Access Compliance Report

Public Rights-of-Way

(Curb Ramps)

Intersection ID: 2743	Main Street: BELL'S_MILL_DR	Cross Street: HIGHLAND_CREEK_PY	Location: SE
ADA ID: 97C4FA12D943	Ramp Type: Perp	Initial Pass/Fail: Fail	Overall Compliance: No
Codes/Mitigation Info/Possible Solution			Severity Score: 10
			Field Measurements/Component Compliance

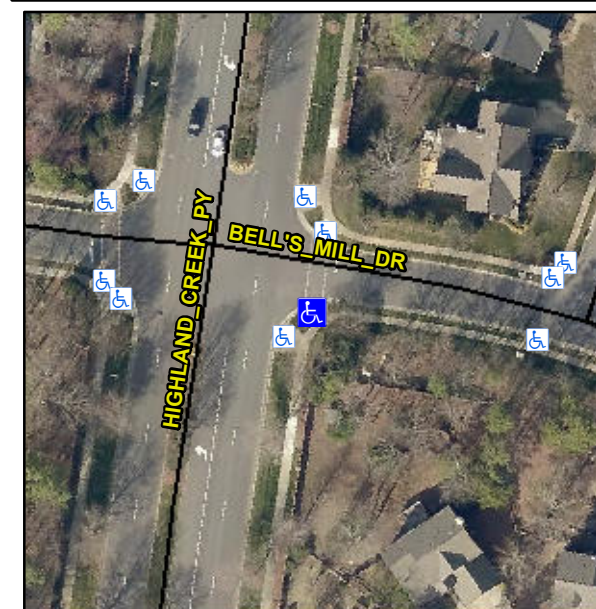
R304.5.1, R304.5.3

Compliance	Description	Data	Compliance	Description	Data
N/A	Ramp Length (in)	86.0	Yes	Ramp Slope (%)	7.8
No	Ramp Width (in)	44.0	No	Ramp XSlope (%)	3.2
N/A	Flare Type LT	N/A	N/A	Flare Type RT	N/A
N/A	Flare Slope LT (%)	N/A	N/A	Flare Slope RT (%)	N/A
N/A	Flare Traversable LT?	N/A	N/A	Flare Traversable RT?	N/A
N/A	Landing Length (in)	N/A	N/A	DWS Provided?	N/A
N/A	Landing Width (in)	N/A	N/A	DWS Contrast?	N/A
N/A	Landing Slope (%)	N/A	N/A	DWS Length (in)	N/A
N/A	Landing X Slope (%)	N/A	N/A	DWS Full Width?	N/A
N/A	Landing Curb? (Y/N)	N/A	N/A	DWS Offset (in)	N/A
N/A	Shared Landing?	N/A			
N/A	Gutter Ponding?	N/A	N/A	Gutter Slope (%)	N/A
N/A	Gutter Lip Ht (in)	N/A	N/A	Gutter X Slope (%)	N/A
N/A	Painted X Walk1?	Yes	N/A	Painted X Walk2?	N/A
	X Walk 1 Direction	To NE		X Walk 2 Direction	N/A
N/A	X Walk 1 Width (in)	96.0	N/A	X Walk 2 Width (in)	N/A
	X Walk 1 Slope (%)	0.2		X Walk 2 Slope (%)	N/A
	X Walk 1 X Slope (%)	0.6		X Walk 2 X Slope (%)	N/A

Remove & Replace Entire Ramp.
